SERVICE BULLETIN

SERVICE BULLETIN		No.: ESB-96E42-503	
		Date: 1997-02-28	<Model> CARISMA
Subject: PROCEDURE FOR RESETTING KEYLESS ENTRY RECEIVER ECU			<M/Y> 96-10
Group: BODY			
Correction	 O. Kai - E.V.P. After Sales Service

Supplementary information needs to be added to the door and keyless entry system troubleshooting section of the manual indicated below, concerning the procedure for Resetting harness circuit error signals that may occur in the keyless entry receiver ECU.

Inspection Procedure 14

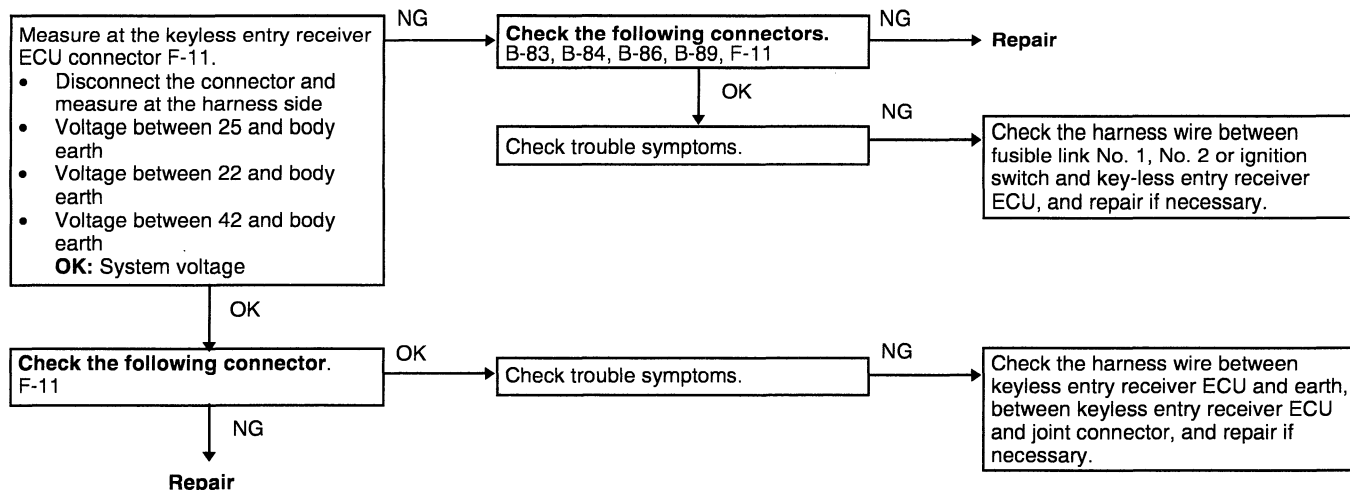
<Added>

If the keyless entry or central door lock system is operated with the No. 2 fuse in the junction block blown or not in place, the keyless entry receiver ECU recognize the condition as a harness circuit problem and set an error status. Once the error status has been set, the keyless entry and central door lock systems will not operate even if No. 2 fuse is replaced of correctly installed. You can reset the harness circuit error signal occurring in the keyless entry receiver ECU and restore normal operation of the keyless entry and central door lock systems by removing the No. 3 fuse in the engine compartment relay box and then replacing it in position.

Inspection Procedure 15

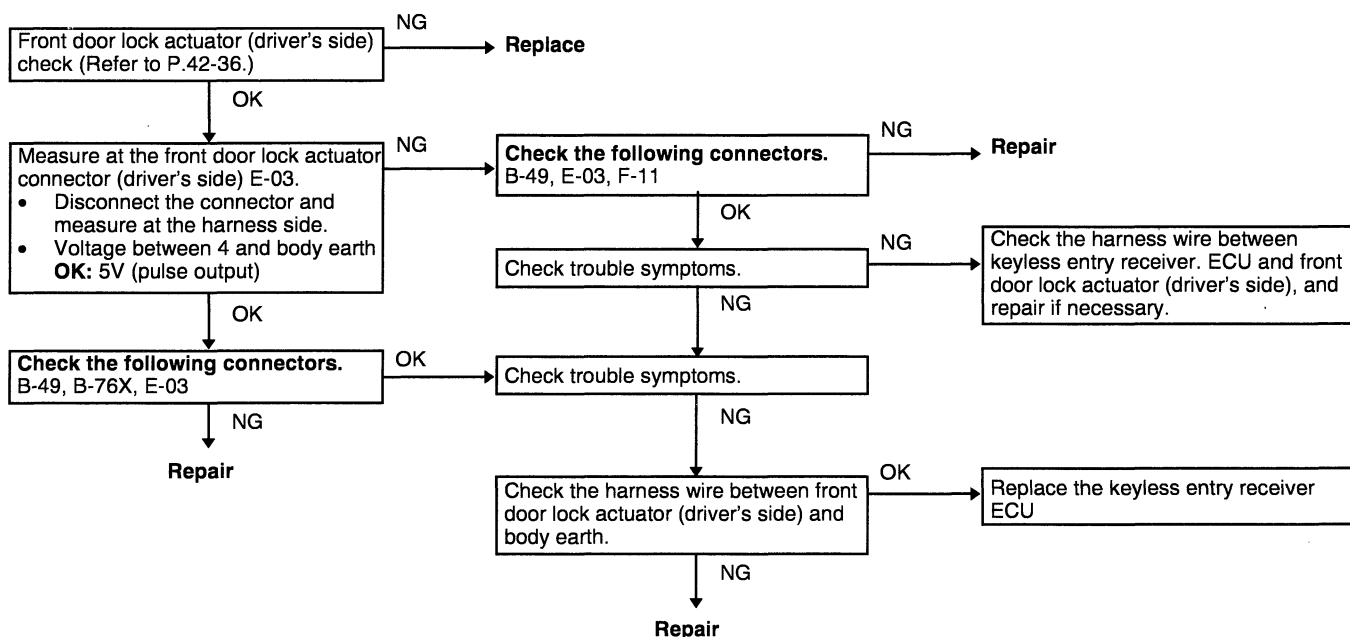
<Added>

If the keyless entry or central door lock system is operated with the No. 2 fuse in the junction block blown or not in place, the keyless entry receiver ECU recognize the condition as a harness circuit problem and set an error status. Once the error status has been set, the keyless entry and central door lock systems will not operate even if No. 2 fuse is replaced of correctly installed. You can reset the harness circuit error signal occurring in the keyless entry receiver ECU and restore normal operation of the keyless entry and central door lock systems by removing the No. 3 fuse in the engine compartment relay box and then replacing it in position.
